**PART 573 DEFECT AND NON-COMPLIANCE REPORT**

Please find enclosed a submission issued pursuant to 49 CFR Part 573 that relates to a safety related defect that has been determined to exist in our 2005 model year Lotus Elise.

# SERVICE BULLETIN

**TITLE:** Fitment of modified gear lever

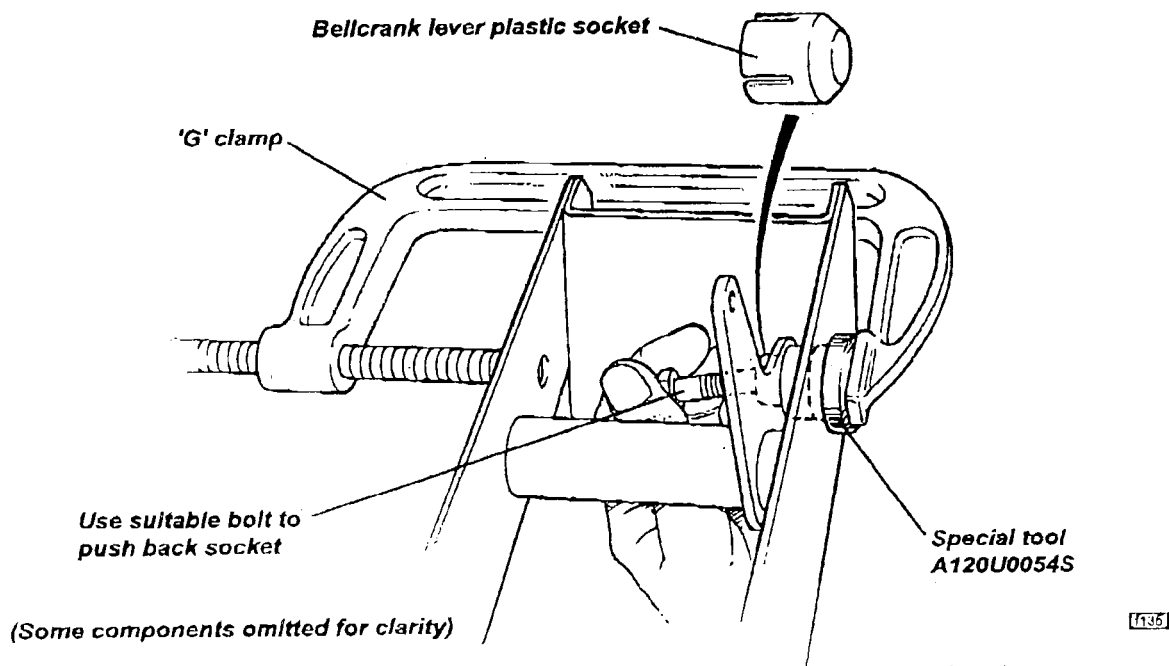
**REASON:** The original gear lever on 6-speed Elise/Exige models (introduced in January 2004) was fabricated from hexagonal section steel bar with welded steel plate reinforcement. It has been found that there is a small risk that this gear lever may break if subjected to high handling force. Lotus is undertaking to replace all early type gear levers with a modified design to assure the highest level of safety.

**ACTION:** All Elise/Exige models in the VIN ranges detailed below are being recalled in order for the gear lever assembly to be updated to an revised design using a larger diameter round section bar of higher material specification.

THE GEAR LEVER ASSEMBLY IS TO BE UPDATED TO A REVISED DESIGN USING A LARGER DIAMETER ROUND SECTION BAR OF HIGHER MATERIAL SPECIFICATION.

THE DEFECTIVE GEAR LEVER HAS A HEXAGONAL CROSS SECTION. THE UPDATED DESIGN UTILISES MATERIAL WITH A ROUND CROSS SECTION.

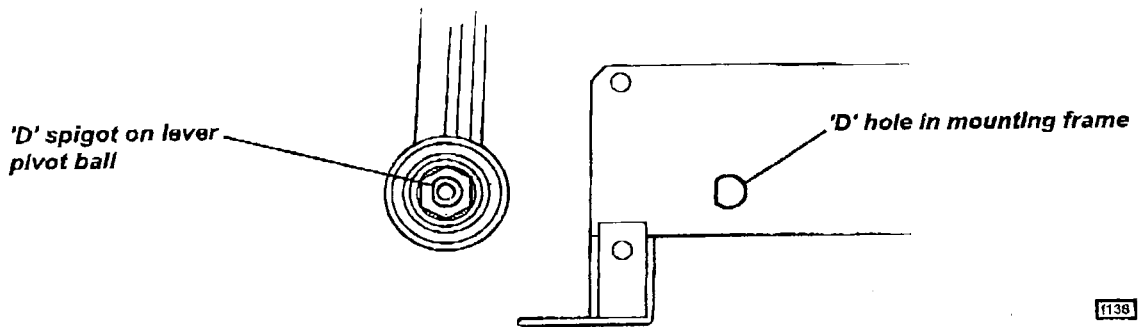
7. To allow fitment of the bush guide tool, unhook the main harness from the 'P' clip at the front of the frame, temporarily hook over the outside of the shroud fixing leg and rotate the 'P' clip 90°. Locate the guide tool in the hole at the RH side of the mounting frame and secure in position using a 'G' clamp as shown, but do not crush or distort the frame.
